Shippensburg University

SUPPLEMENT 1 Electrical Coordination Study

Professional:
Entech Engineering, Inc.
4 South Fourth Street
P.O. Box 32
Reading, PA 19603
Telephone: 610-373-6667
Fax: 610-373-7537
www.entecheng.com
Entech Project #: 2184.22

August 24, 2004

TCC Name: TR4-5 CUMBERLAND STUDENT UNION
Rev. 0.0
Date: March 12, 2004

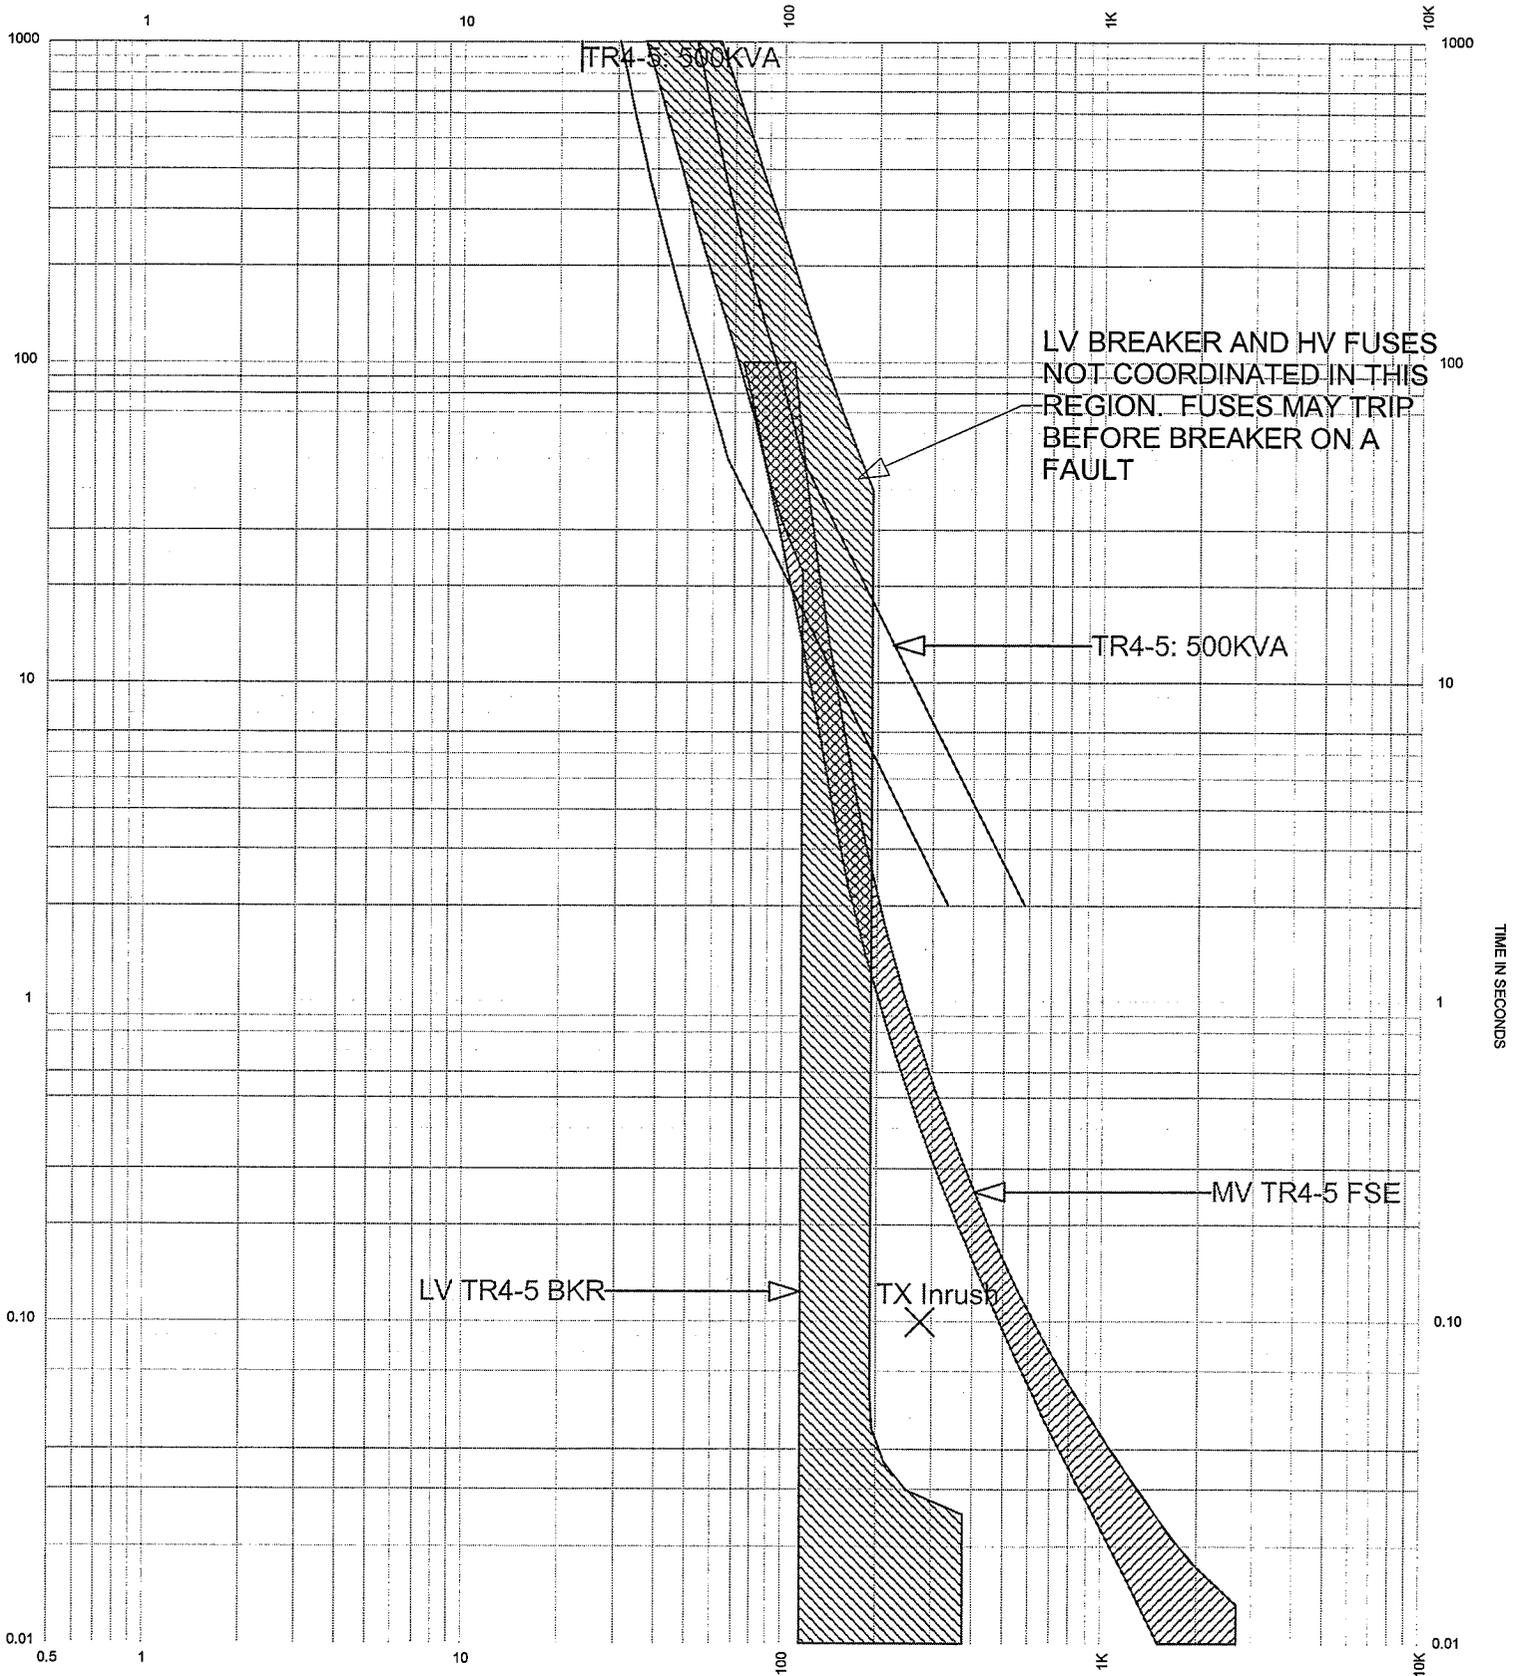
TCC TR4-5 The Cumberland Student: The main secondary circuit breaker and primary fuses are not coordinated in the short time and long time regions. Although there is an instantaneous pickup dial on the circuit breaker, there is not enough adjustment to coordinate it with the primary fuses. Therefore, replacement of this breaker is recommended. A static trip (solid state) breaker with long-time, short-time, and instantaneous pickup and delay settings could be installed in place of the existing secondary main circuit breaker. A static trip breaker would permit greater flexibility for coordinating with the primary fuses.

TCC Name: 1203
 Rev. 0.0
 Date: August 12, 2004

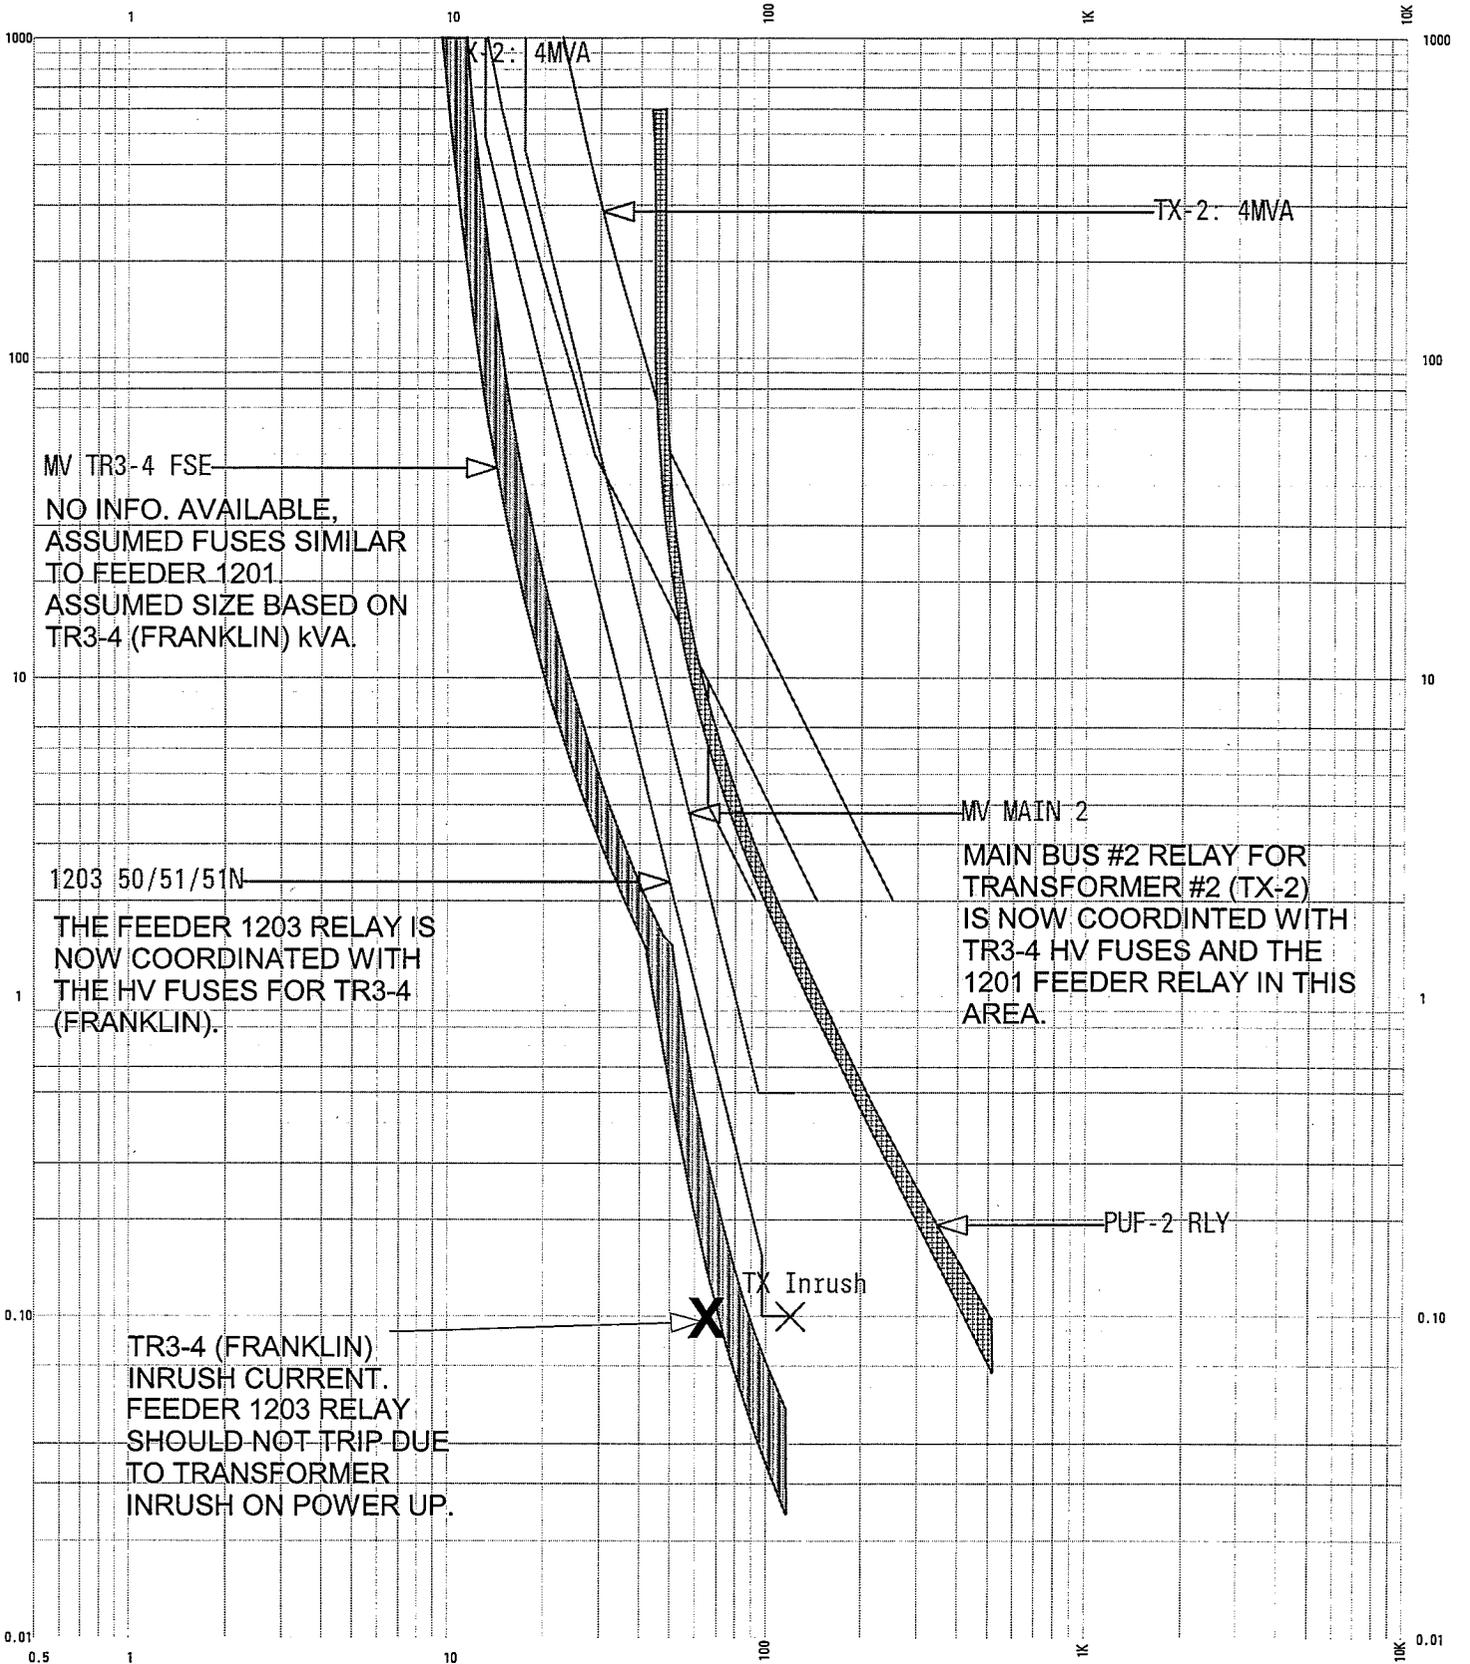
3. The Main Bus #2 relay is not properly coordinated with the assumed medium voltage fuses for TR3-4 on feeder 1203 in the short time region.
4. The 1203 feeder relay trip curve crosses the inrush point for the Franklin Science Center transformer(TR3-4). Therefore, the 1203 relay could trip before the TR3-4 fuses on a down stream fault or on power up of TR3-4.

RECOMMENDED RELAY SETTINGS*						
Setting	Main #1	Main #2	1201	1202	1203	1204
Curve	I4T	I4T	I4T	I4T	I4T	I4T
LTPU	0.8	0.8	1.2	1.2	1.2	1.2
LTD	2.25	2.25	12.5	12.5	12.5	12.5
STPU	4.5	4.5	9.0	9.0	9.0	9.0
STD	0.5	0.5	0.1	0.1	0.1	0.1
INST	25	25	—	—	—	—

TCC's 1201, 1202, 1203, and 1204 in Appendix B of this supplement show the recommended curves based on these settings. The actual fuse rating for TR3-4 should be determined prior to resetting relay values as lower values may be possible.
